***MODIFICATION REQUEST:
Hurstville Private Hospital
37 Gloucester Road, Hurstville
(MP 11_0042 MOD 2)***

Modification to the internal layout, changes to the façade, increase in height of the lift shaft and expanded plant area on the rooftop

Secretary's Environmental Assessment Report
Section 75W of the *Environmental Planning and
Assessment Act 1979*

December 2014

Figure 2 – Location of lift core and plant area on roof

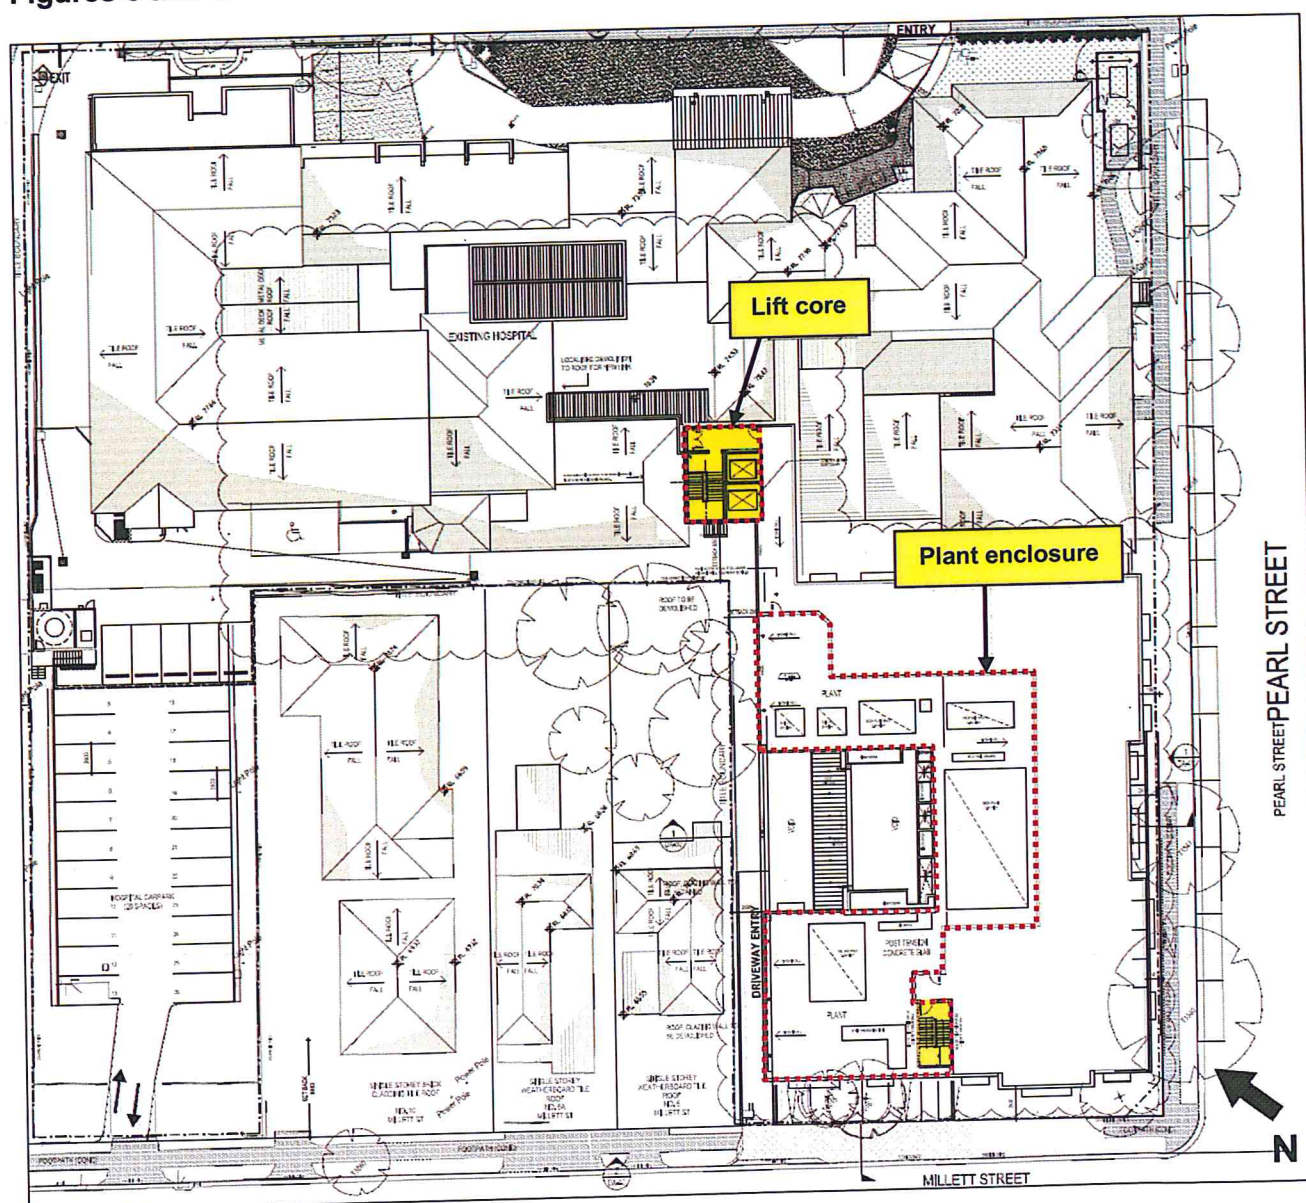
The proposed modification also seeks to expand the footprint of the mechanical plant on the rooftop (see **Figure 2**) which would add to the height and bulk of the main hospital building when viewed from the west. The previous modification application (MOD 1) approved the removal of an entire floor from the main hospital building, resulting in a corresponding reduction in height by approximately 2 m compared to the originally approved development application. The additional plant area proposed in this modification application would be contained within the originally approved building envelope, and there would be no additional visual or amenity impacts to adjoining properties beyond that which has already been assessed as reasonable in the originally approved application (refer to **Figure 5**). The Department therefore concludes that the additional bulk and height associated with the expanded footprint of the plant area to be acceptable.

Figure 4 – View from the rear of No. 6 Millet Street (as proposed)

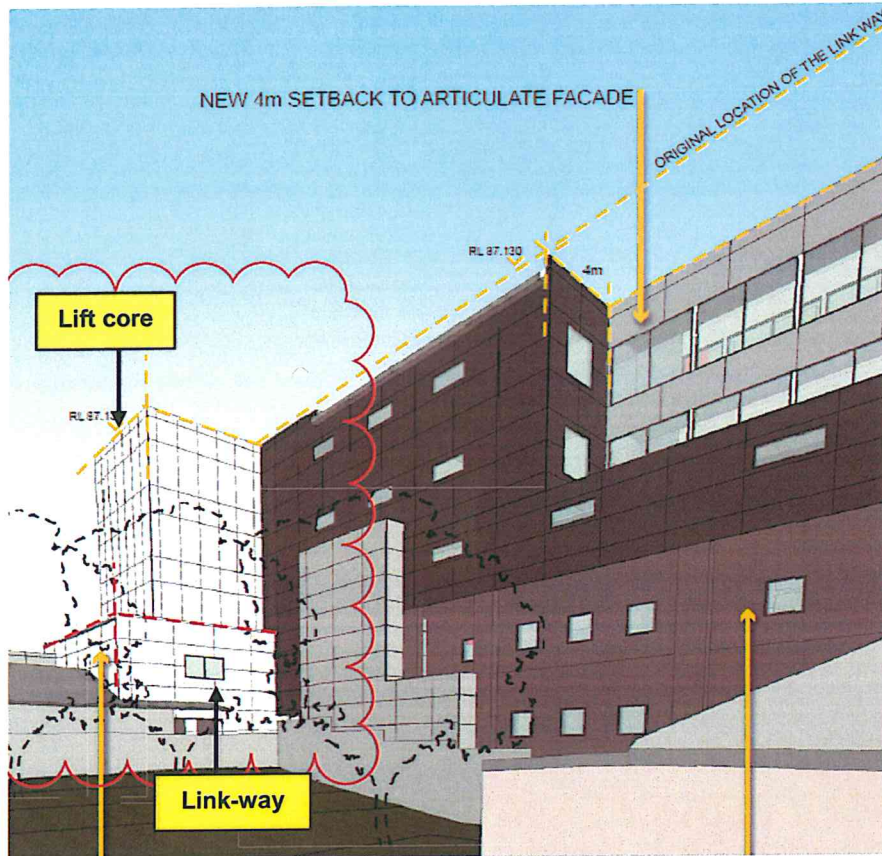
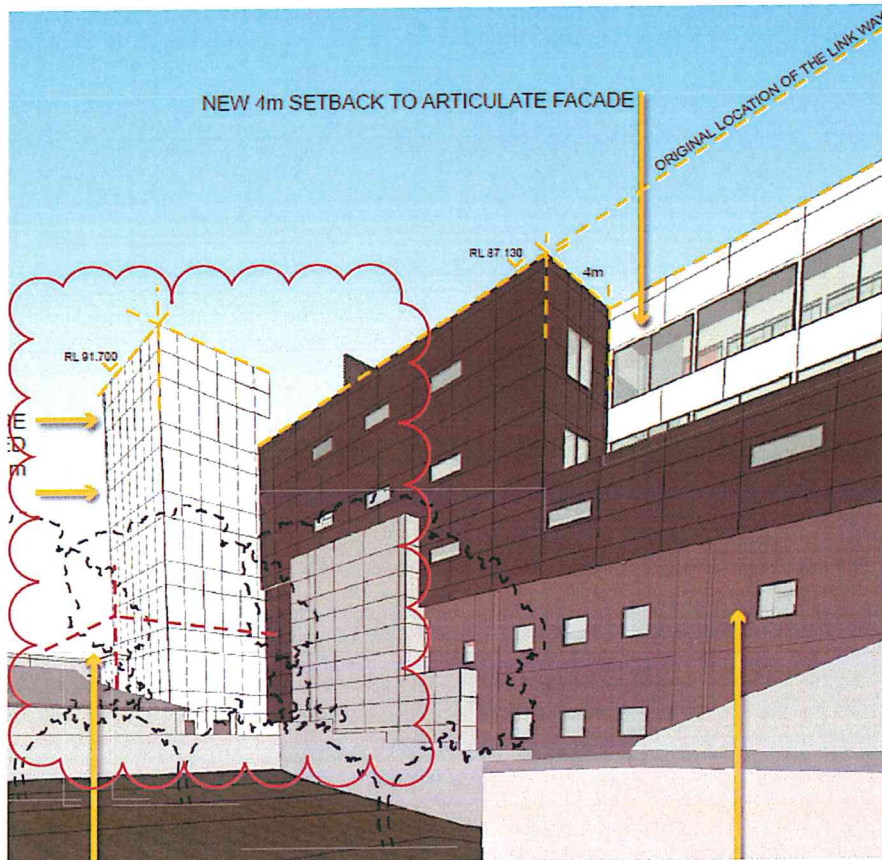
The approved development includes a lift core in the main hospital building which terminates at Level 4 (the top floor). The modification application seeks approval to extend the lift core and stairs to the rooftop to facilitate proper access for the maintenance of the mechanical plant. As a consequence, the parapet height of the lift overrun would increase by 2.52 m above its approved height. The location of the lift core and proposed plant rooftop enclosure is shown in **Figure 2** and a comparison between the approved development and the proposed modification is illustrated in **Figures 3 and 4**.

The Department notes a key assessment issue relates to the increased height and any resultant adverse visual impact from the public domain. The lift core is centrally located on the northern side of the main hospital building which is 40 m to 50 m to the nearest street frontages. The proposed additional height of the lift overrun would therefore be relatively unobtrusive when viewed from the surrounding streets due to the generous separation distance. The Department concludes that the proposed additional height of the lift overrun would not give rise to any significant visual impact when viewed from the public domain.

The additional height associated with the lift core also has the potential to adversely impact on the amenity currently enjoyed by the adjoining low scale residential properties directly to the south-west, fronting onto Millett Street. The proposed additional height would be readily visible above the parapet of the main building from these properties. However, the additional height would be offset by the removal of the link-way at the base of the lift core (as a consequence of the link corridor being relocated to the Gloucester Road side of the core), which would introduce a more slender building form (see **Figure 4**). The additional height associated with the lift overrun would also introduce some articulation to the roof line and assist in breaking up the mass of the building when viewed from the rear of the adjacent residential properties. Shadow diagrams submitted with the modification application demonstrate that there will be negligible additional shadow impacts on the rear of residential properties in Millett Street.

The Department is satisfied that reasonable access to sunlight and ventilation would be maintained to adjoining residential properties, and in the absence of any amenity impacts, concludes that the visual impact associated with the additional height of the lift parapet is reasonable.
